**RE: Variation No. 1 Clare County Council Development Plan 2023-2029, Vol.3a(iv)
 adoption of Ennis Local Transport Plan - Connecting Tulla Road to Gort Road Ennis.**

Additional information supporting objections to:

Extract from Clare Development Plan map 2023-2024 showing Corrovorrin area as Flood Zones A & B along with open space zoning of field behind Corrovorrin Drive

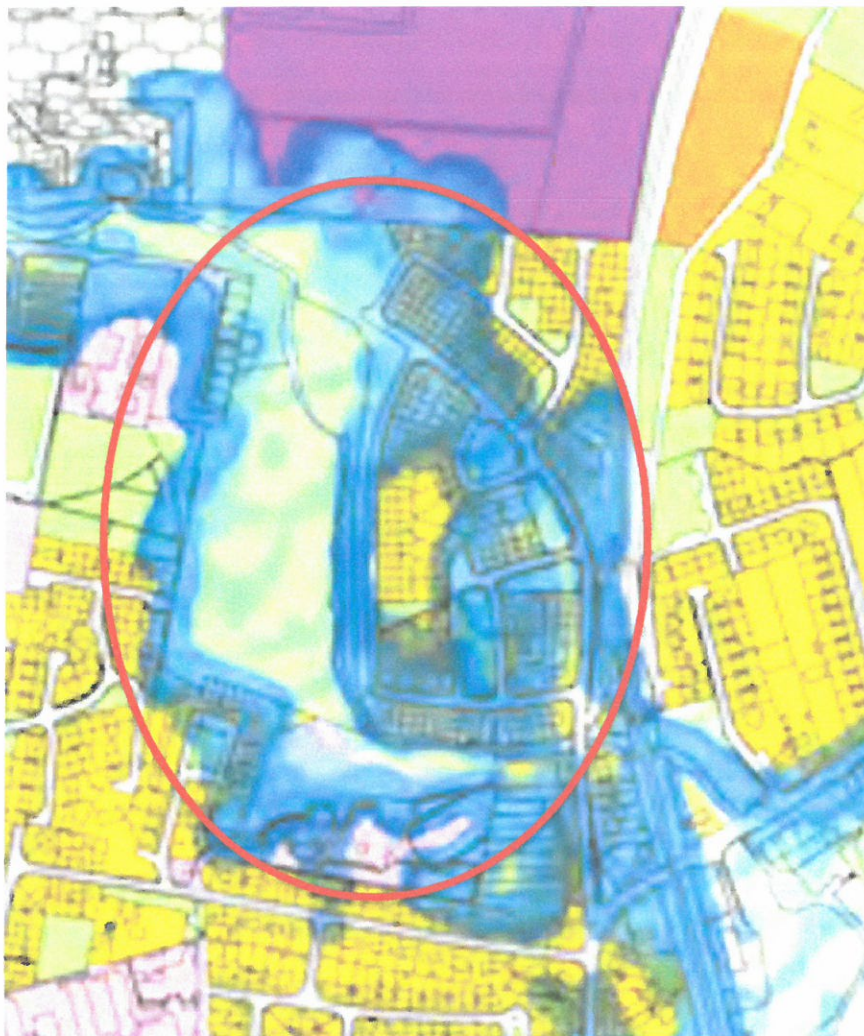
The field running from the Corrovorrin graveyard along the back of Corrovorrin Drive is within Flood Zone A and is a Riparian zone. Zoned as open space it is home to wide variety of wildlife including protected species such as Otters and Kingfishers (which are Amber-listed (Birds of Conservation Concern in Ireland)). There are also regular sightings of bats in both the graveyard and the field. Any kind of development in this field will cause significant disruption to the feeding and breeding grounds of these and many other species of wildlife who have flourished in this undisturbed environment over the last few years.

This land is an essential part of the conservation of the wildlife of the River Fergus and as such is entirely unsuitable for development.
